Report: ISSUE REPORT
Function: Test, Adjust, & Balance
Date: 02/08/2024

PROJECT
02-05-24 PERRY'S - VERNON HILLS, IL

Issue List

Speedtaps
02/08/2024

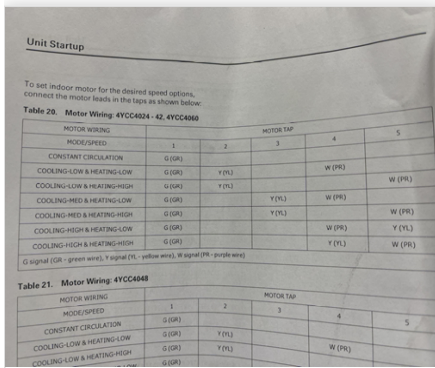
Issue Name : RTU-4: High on airflow
Description : RTU-4 is multispeed unit scheduled for 600cfm with speed taps. Plans call for constant volume. Unit is within design at Speed tap 1, where G is landed. Manual indicates placing W(heat) at 4 and Y (cool) at tap 2, puts heating and cooling to low speed, this is 940cfm. Not possible to wire all stages to same speed. No indication if jumpers are allowed.

RTU_5_CONTROLBOARD.jp..
02/08/2024

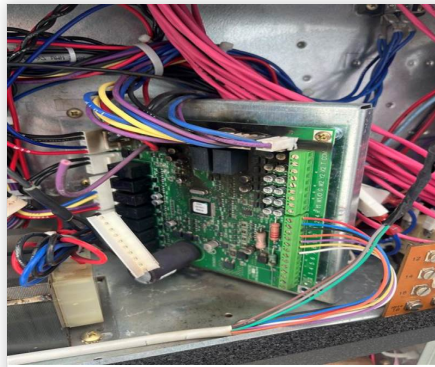
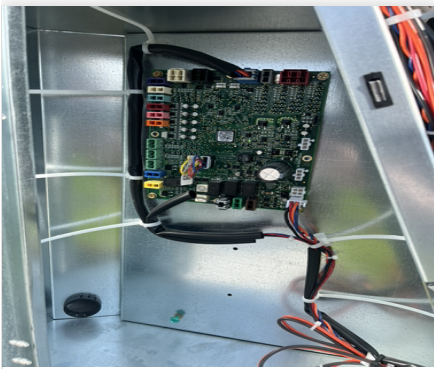
Issue Name : RTU-5: Not Operational
Description : RTU-5 is not operational as the control board is fried. Waiting on replacement board. Unit not yet balanced as result.
Created By : National TAB **Assigned To :** National TAB - Michael McDonnell
Status : Open
Priority : High **Asset Tag :**
Originated Date : 02/08/2024 - Michael McDonnell - National TAB
